NURSERY ROAD DEVELOPMENT SUBDIVISION

APPLICATION NUMBER 15 DATE September 20, 2007

APPLICANT Nursery Road Development

DETAIL SITE PLAN

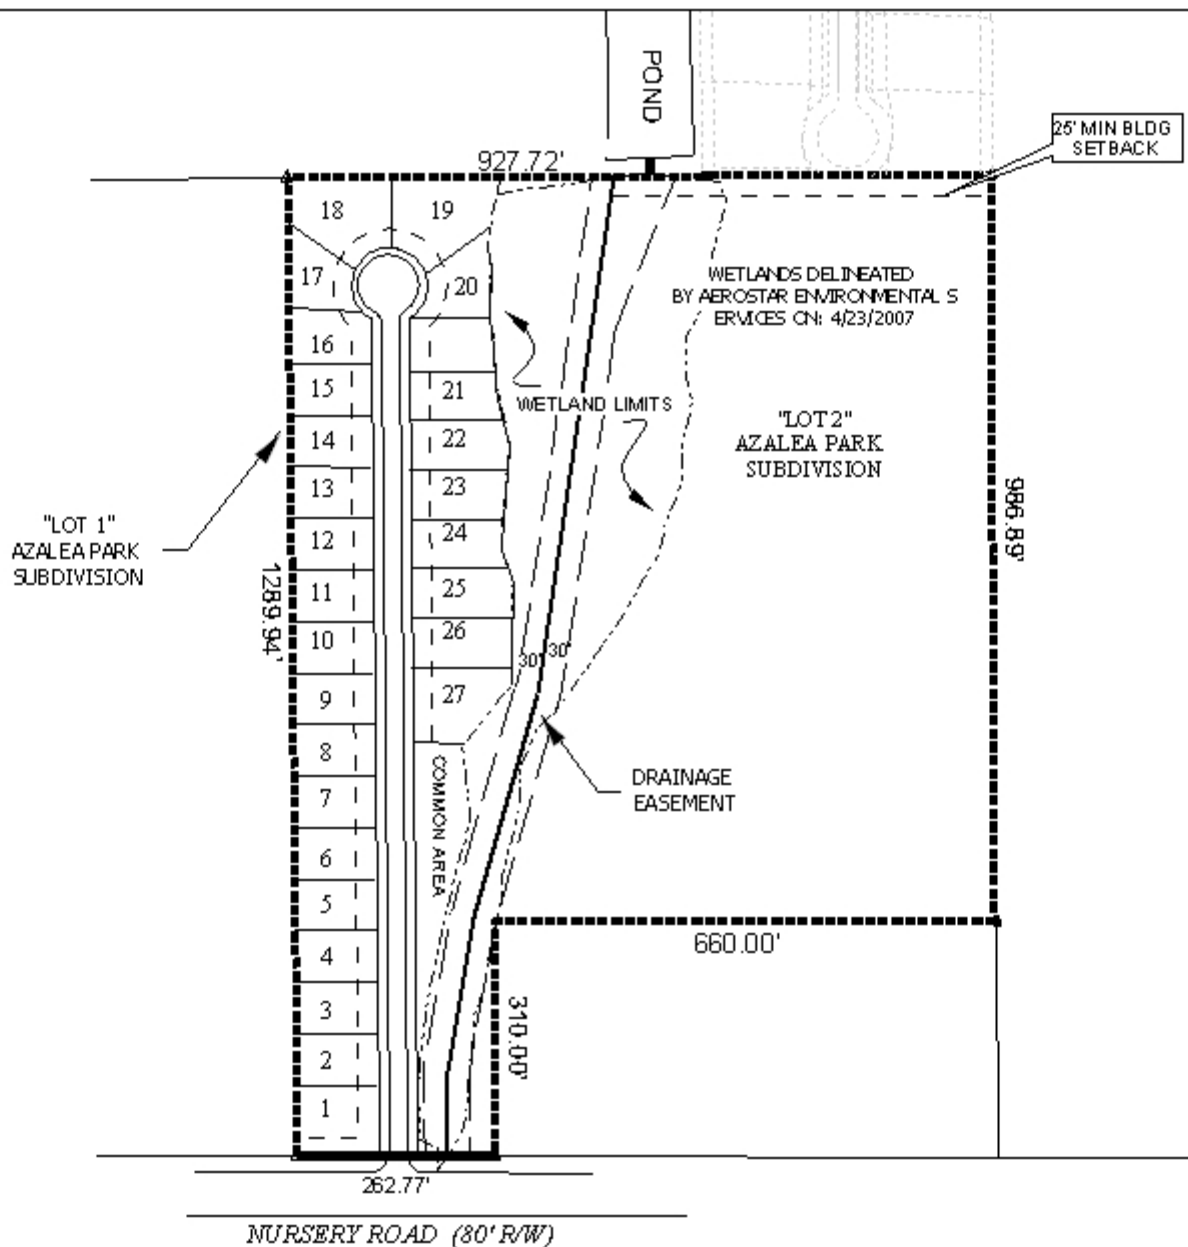
The plotted plat scale is 1 inch equals 100 feet, while the labeled scale is 1 inch equals 200 feet. The drawing should be revised to correct this error.

The site fronts Nursery Road, a minor street with a right-of-way of 80-feet. A cul-de-sac is proposed as part of the development, however, the length of the cul-de-sac is approximately 1,150 feet, which greatly exceeds the maximum of 600 feet as stated in Section V.B.6. of the Subdivision Regulations. Furthermore, the length of the cul-de-sac and the diameter of the cul-de-sac do not comply with the minimum requirements of Appendix D of the 2003 International Fire Code, as adopted by the City of Mobile (while the site is outside of the City of Mobile Fire jurisdiction, the design of the Subdivision must comply with the requirements of the International Fire Code – Mobile County has adopted the latest version, 2006). The design of the subdivision should be revised to comply with the design requirements of Appendix D of the International Fire Code, as adopted by the City of Mobile.

It appears that each proposed lot will meet the minimum area requirements of the Subdivision Regulations for lots with public water and sanitary sewer facilities. Access management is a concern, however, due to the size of the lots. Each lot should be limited to one curb-cut onto the

cul-de-sac that is part of the subdivision, with the size, design and location to be approved by the Mobile County Engineering Department. Direct access from any lot onto Nursery Road should be denied.

The plat illustrates that wetlands are present on the property, and thus some parts of the site may be considered environmentally sensitive, therefore, approvals from federal, state, and local agencies will be required prior to the issuance of any permits.

The 25-foot minimum building setback is shown on the plat, but is not labeled. The setback line should be labeled.

Common areas proposed for the subdivision. All common areas should be labeled, and a note should be placed on the Final Plat, if approved, stating that maintenance of the common areas, including detention and wetland areas, and any other common areas, are the responsibility of the subdivision's property owners

The plat should be revised to show lot size in square feet, or a table provided on the plat with the same information.

With a waiver of Section V.B.6. for the cul-de-sac length, the Subdivision request is recommended for Tentative Approval, subject to the following conditions:

- 1) Correction of the legal description to reflect the recorded lot;
- 2) Correction of the scale issues between the drawing and the labeled scale in the title block;

- 3) Redesign of the subdivision to comply with Appendix D of the 2003 International Fire Code, as adopted by the City of Mobile, and certification by the engineer or surveyor that the subdivision layout and design complies with the requirements of the 2003 International Fire Code, including Appendices B through D, as adopted by the City of Mobile, placed as a note on the final plat;

- 4) Labeling of the 25-foot minimum building setback line;
- 5) Placement of a note on the plat stating that each lot is limited to one curb-cut onto the subdivision's cul-de-sac, and that all lots are denied direct access to Nursery Road, with the size, location, and design of all curb-cuts to be approved by the Mobile County Engineering Department;

- 7) Labeling of all common areas, including detention areas and wetlands, and placement of a note on the plat stating that maintenance of all common areas is the responsibility of the property owners;

- 10) Labeling of each lot in square feet, or provision of a table with the same information.
